Backfeed v230

Changelog:

v230 Added PSE requirement to limit current to I_{rev} , different level depending on V_{PSE} , PD 3P spec reduced to detection range only.

Figure 145–29a — Reflected voltage requirements

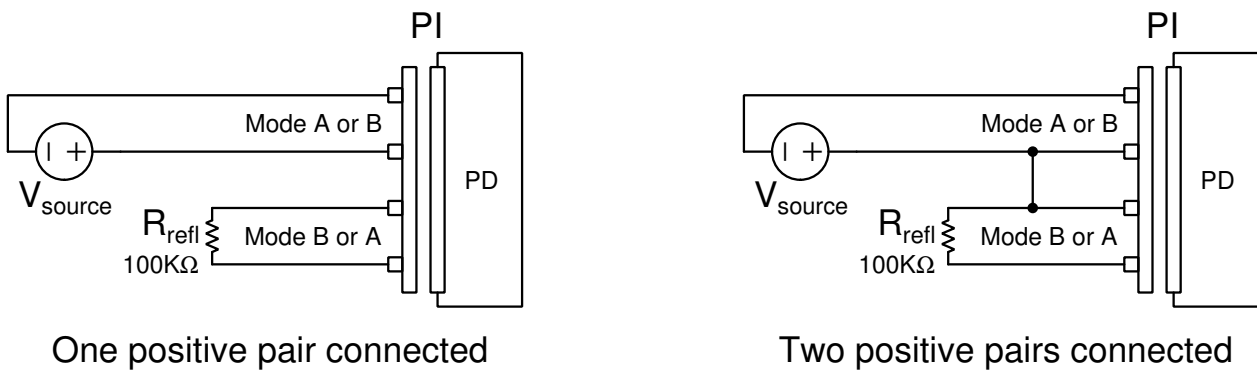
For a single-signature PD, when any voltage in the range of 0 V to $V_{Port_PD-2P\ max}$ is applied per any of the valid 2-pair configurations, defined in Table 145–20, that have only a single pair connected to positive V_{PSE} (see Figure 145–29a), the voltage on the Mode not connected to the voltage source, with a 100 k Ω resistor connected across that Mode, shall not exceed V_{refl} as defined in Table 145–29.

For a single-signature PD, when any voltage in the range of 0 V to 10.1 V is applied per any of the valid 2-pair configurations, defined in Table 145–20, including those with two pairs connected to positive V_{PSE} (see Figure 145–29a), the voltage on the Mode with at least one pair not connected to the voltage source, with a 100 k Ω resistor connected across that Mode, shall not exceed V_{refl} as defined in Table 145–29. This requirement does not apply if a voltage greater than 10.1 V has been applied on either Mode until the voltage on both Modes has been less than V_{Reset} for at least T_{Reset} .

For a dual-signature PD, when any voltage in the range of 0 V to $V_{Port_PD-2P\ max}$ is applied per any of the valid 2-pair configurations, defined in Table 145–20, including those with two pairs connected to positive V_{PSE} (see Figure 145–29a), the voltage on the Mode with at least one pair not connected to the voltage source, with a 100 k Ω resistor connected across that Mode, shall not exceed V_{refl} as defined in Table 145–29.
